A007090287 – Information Request Response

Development at 171-173 Upper Kedron Road / 24 Persimmon Street Ferny Grove QLD 4055

In response to Councils Information Request dated 18th of September 2026, please find below information which will form the response to items 5 , 7, 8 , 9 & 10 outlined in the information required.

Figure 4.4 – Overland sheet flow times (shallow sheet flow only) (source: ARR, 1977)

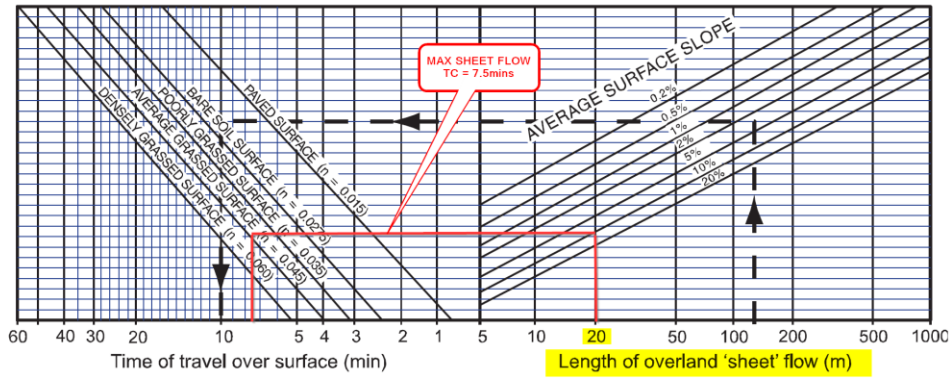
a. The hydrological analysis for existing conditions would typically use a Tc value based on overland sheet flow over a >200metre flowpath with averaged grass surfaces likely resulting in a TC >10 minutes for pervious catchments. That the use of standard inlet times is not suitable for detention sizing where detailed hydrological calculations are required. Provide a recalculate detention sizing based on detailed hydrological calculations as per QUDM standards.

The existing topography has an average grade of 10%. In accordance with QUDM Section 4.6.6, *Overland Flow Travel Times*, and Table 4.6.4, *Recommended Maximum Length of Overland Sheet Flow*, the recommended maximum sheet flow length for steep grassland (>10% grade) is 20 m.

Based on QUDM Figure 4.4, the corresponding time of concentration for the above criteria is approximately 7.5 minutes.

Beyond this point, it is assumed that the overland sheet flow will begin to concentrate into rills and can therefore be treated as channel flow. The remaining 180 m of the catchment is treated as channel flow, as follows:

Based on the above, a pre-development time of concentration of 10 minutes has been adopted.
